NOTICE OF A TYPE II DECISION ON A PROPOSAL IN YOUR NEIGHBORHOOD

CASE FILE NUMBER: LU 08-126591 DZ – DESIGN REVISIONS FOR THE FEDERAL RESERVE BUILDING [PREVIOUSLY APPROVED LU 07-149484 DZ]

30 April 2008
Federal Reserve Exterior Alterations
Design Review Type II Revision to LUR 07-149484 DZ

WEST ELEVATION
 3/16" = 1'-0"

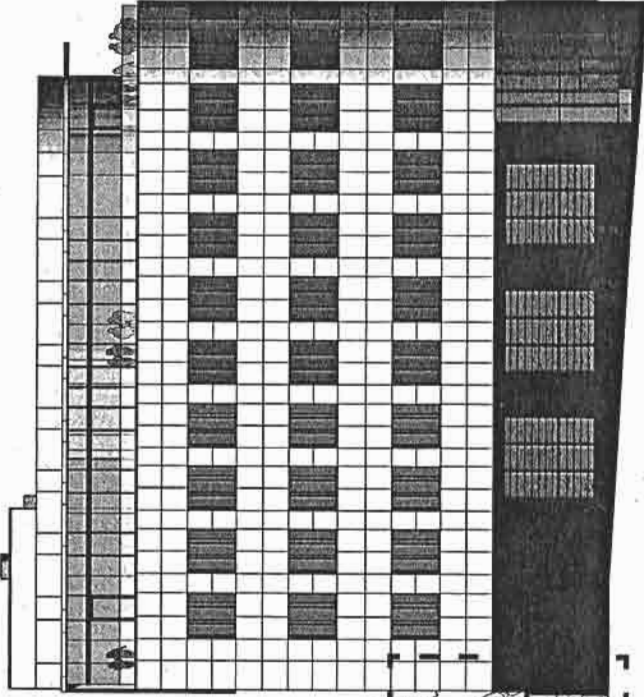
AREA OF REVISED DESIGN

METAL AND GLASS CANOPY BEYOND
